FILE NUMBER: PLN23-100
SUBJECT: Major Reclamation Plan Amendment
SITE LOCATION: 24001 Stevens Creek Blvd.
DATE RECEIVED: June 14, 2023

The purpose of this letter is to inform you that the Major Reclamation Plan Amendment (RPA) application ("Application") submitted by Lehigh Southwest Cement Company ("Lehigh") on June 14, 2023, has been deemed **incomplete**. To complete the Application, Lehigh shall submit the following information requested in Section II (Summary of Required Supplemental Information) no later than 180 days from the date of this letter.

Subject: Preliminary Review Comments of the Geologic and Geotechnical Portions of the Reclamation Plan Amendment, Permanente Quarry, CA Mine ID 91-43-0004, Santa Clara County, California, dated June 2023

Geologic and Borehole Location Map (Comment 1)

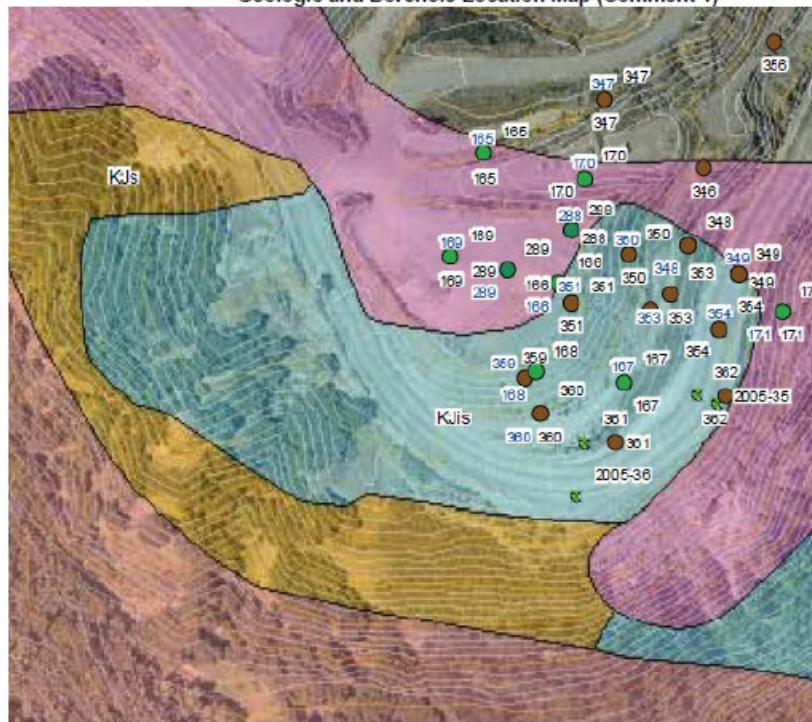
1. The word Quaternary is misspelled twice.
2. The map is missing a north arrow.
3. The map is missing a scale.
4. The geologic map units, except for KJs and KJis, are missing from the map.
5. Map unit KJis is listed as limestone – limestone is typically designated as “ls” or “l”.
6. The geologic contacts are missing from the legend.
7. The geologic units are listed from oldest to youngest – the most common convention is to list them from youngest to oldest.

8. The Santa Clara Formation (QTsc) is of Pleistocene and Pliocene age, designated as QT – Quaternary/Tertiary, not just “QUARNTERNARY”.
9. The legend does not identify the type of borings based on their color.
10. Many borings are shown with duplicates or triplicates of the same number without explanation.
11. There are no elevations shown on the underlying topographic contours.
12. There are no geologic cross sections shown on the map.
